RENESAS TECHNICAL UPDATE

Product Category	MPU/MCU		Document No.	TN-SY*-A0040A/E	Rev.	1.00
Title	Errata for User's Manual regarding the IIC		Information Category	Technical Notification		
Applicable Product	Renesas Synergy™ S7G2 MCU Group	Lot No.	Reference Document	S7G2 Microcontroller Group User's Manual Rev.1.40		
		All

The specified Renesas Synergy S7G2 User's Manual has incorrect statements about the IIC.

Page 1256 of 2117

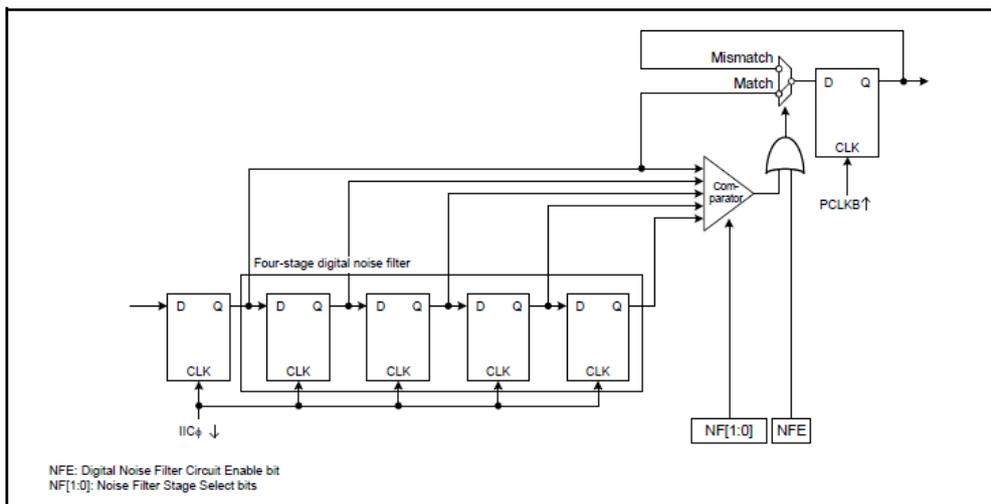
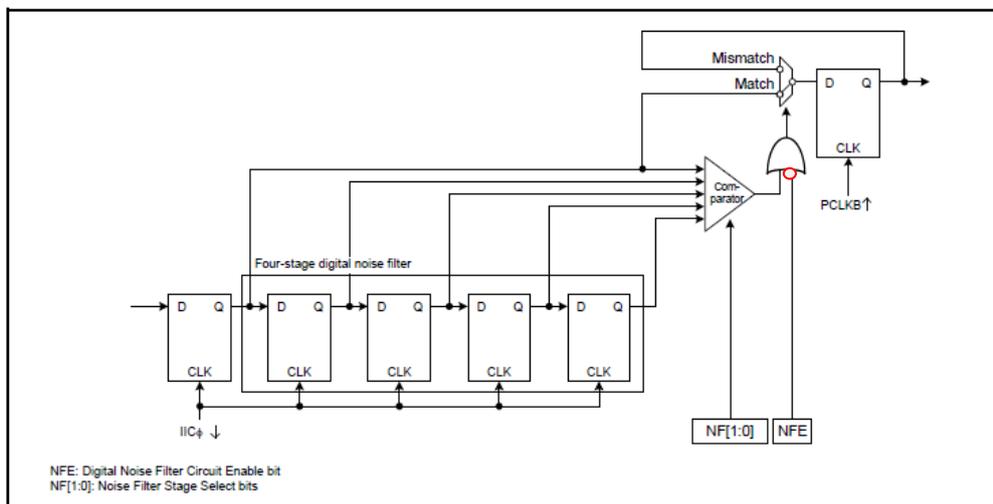
Incorrect

The IIC can also set the flag to indicate the detection of arbitration loss during NACK transmission in master mode or during data transmission in slave mode.

Incorrect Figure

Correct

The IIC can also set the flag to indicate the detection of arbitration loss during NACK transmission ~~in master mode~~ or during data transmission ~~in slave mode~~.

Correct Figure

Incorrect Figure

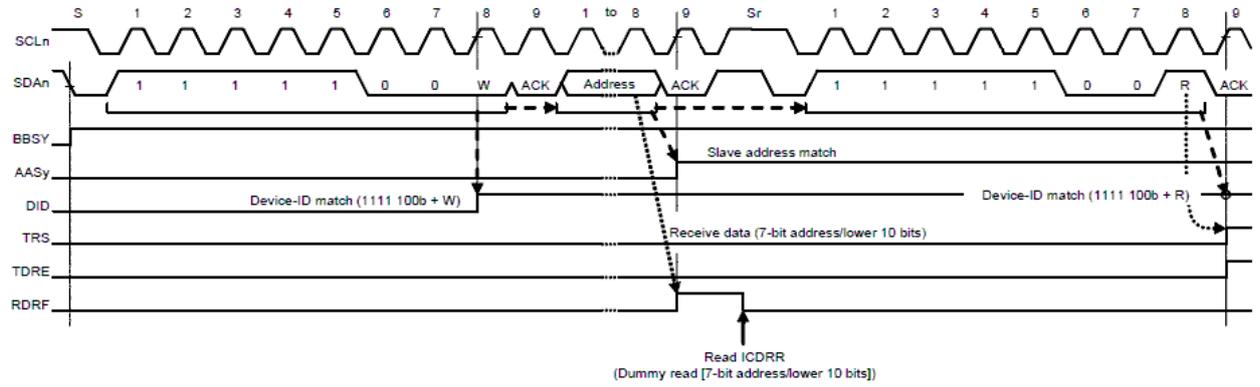
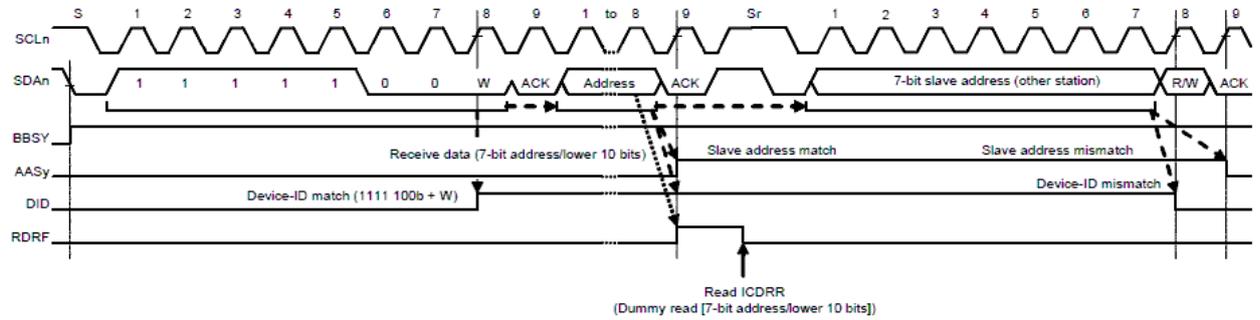
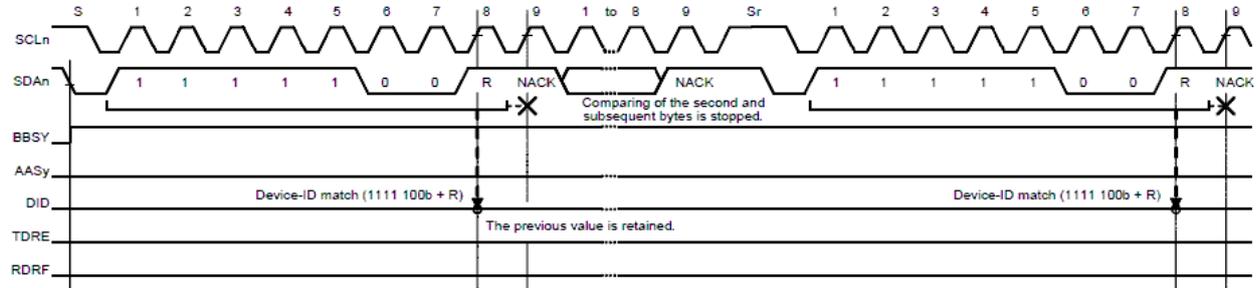
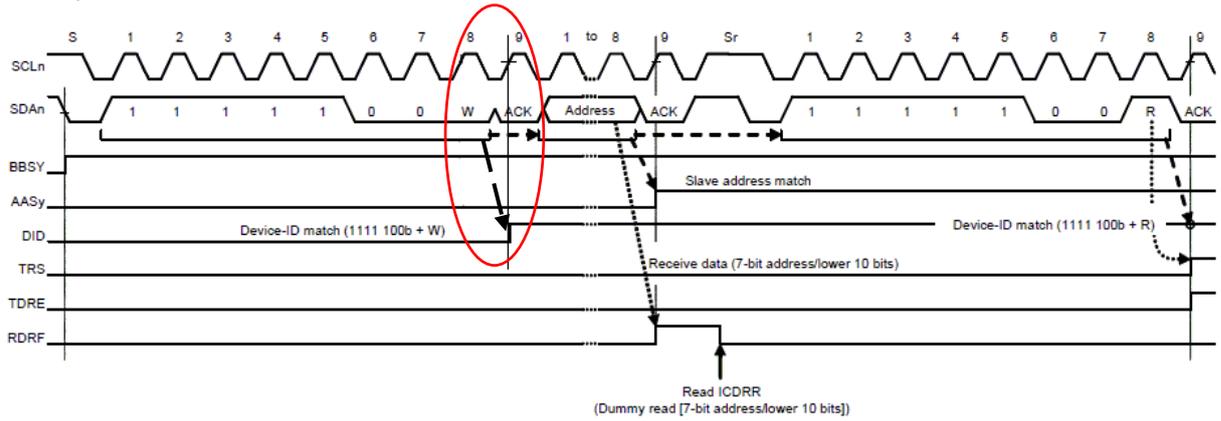
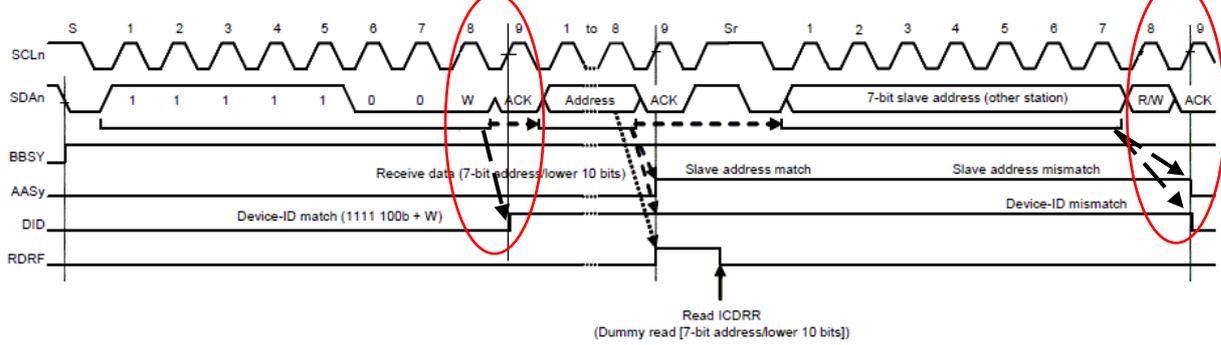
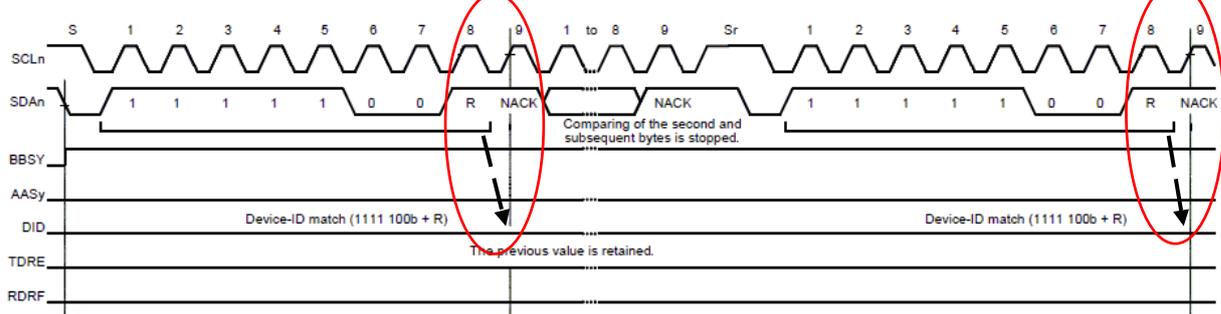
Incorrect

The IIC module provides detection of device-ID address compliant with the I2C bus specification (revision 03). When the IIC receives 1111 100b as the first byte after a start or restart condition was issued with the DIDE bit in ICSER set to 1, it recognizes the address as a device ID, sets the DID flag in ICSR1 to 1 on the rising edge of the eighth SCL clock cycle when the subsequent R/W# bit is 0, and then compares the second and subsequent bytes with its own slave address.

Device-ID reception

When address received after a restart condition is detected does not match the device-ID

When address before the device-ID + R does not match the slave address

Correct

The IIC module provides detection of device-ID address compliant with the I2C bus specification (revision 03). When the IIC receives 1111 100b as the first byte after a start or restart condition was issued with the DIDE bit in ICSER set to 1, it recognizes the address as a device ID, sets the DID flag in ICSR1 to 1 on the rising edge of the **9th** SCL clock cycle when the subsequent R/W# bit is 0, and then compares the second and subsequent bytes with its own slave address.

Correct Figure

Device-ID reception

When address received after a restart condition is detected does not match the device-ID

When address before the device-ID + R does not match the slave address

Page 1295 of 2117

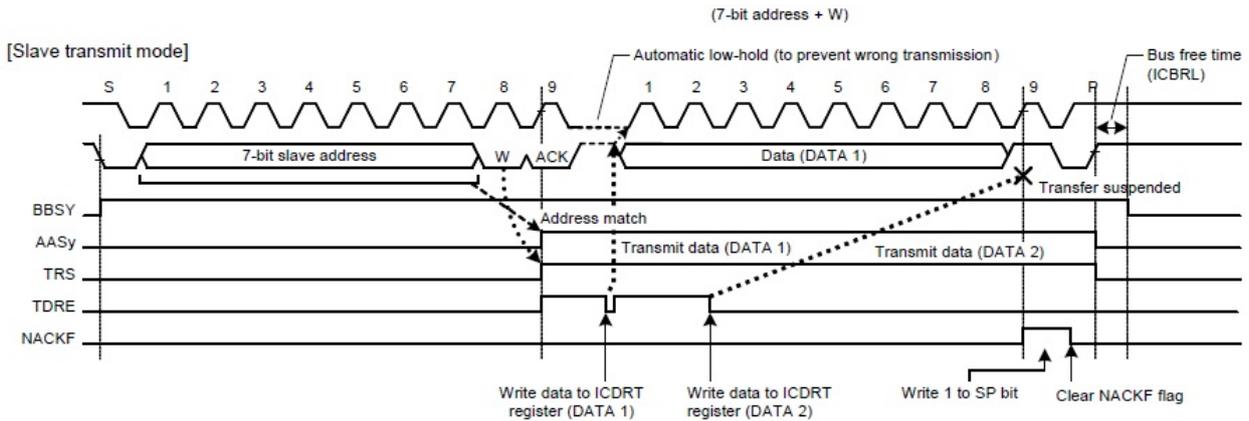
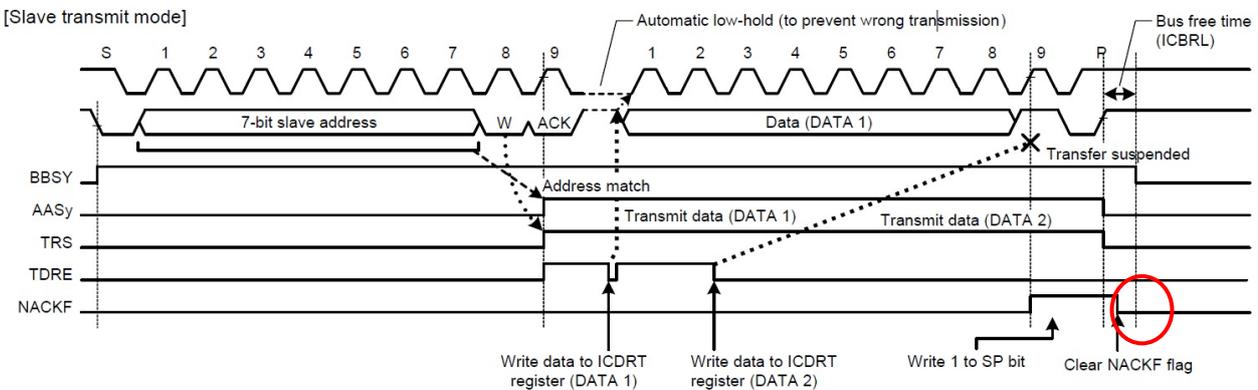
Incorrect Figure

Correct Figure

Page 1305 of 2117

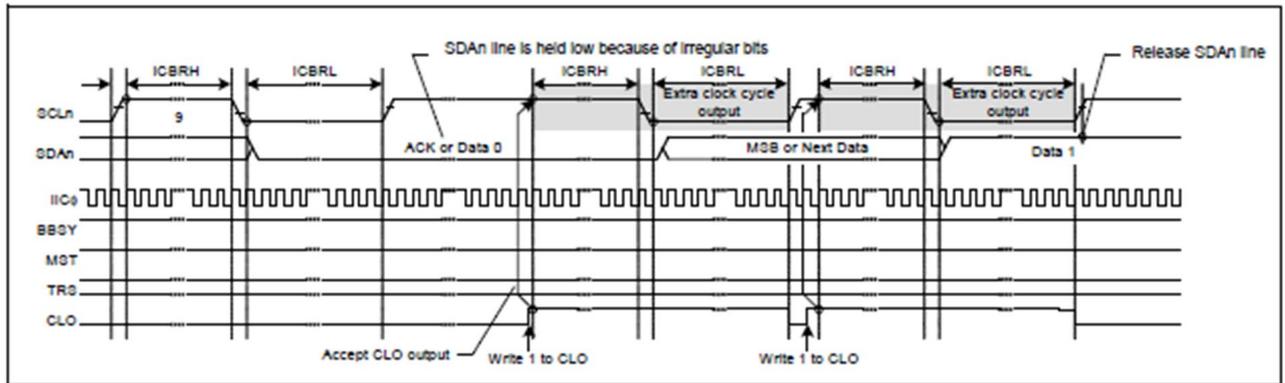
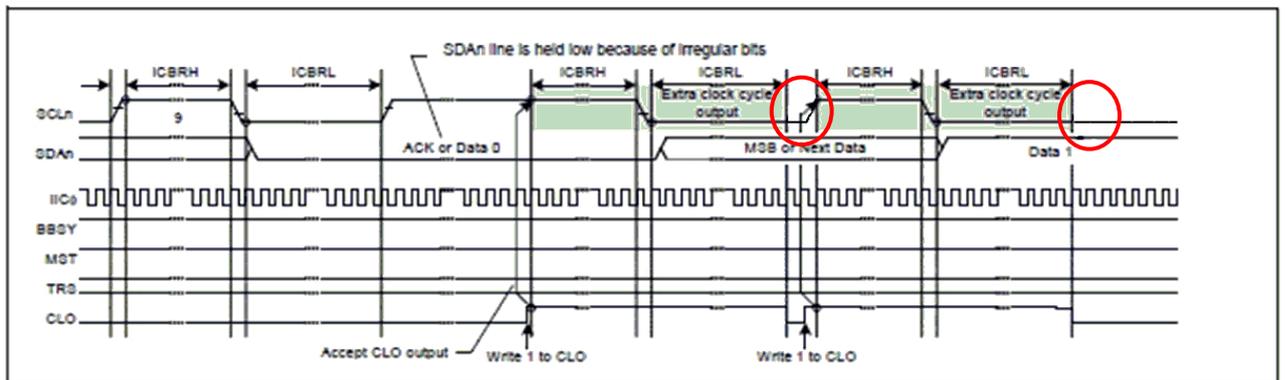
Incorrect

Use this function with the MALE bit in ICFER set to 0 (master arbitration-lost detection disabled). If the MALE bit is set to 1 (enabled), arbitration is lost when the value of the SDAO bit in ICCR1 does not match the state of the SDAn line.

Incorrect Figure

Correct

Use this function with the MALE bit in ICFER set to 0 (master arbitration-lost detection disabled). If the MALE bit is set to 1 (enabled), arbitration is lost when the value of the SDAO bit in ICCR1 does not match the state of the SDAn line.

Correct Figure
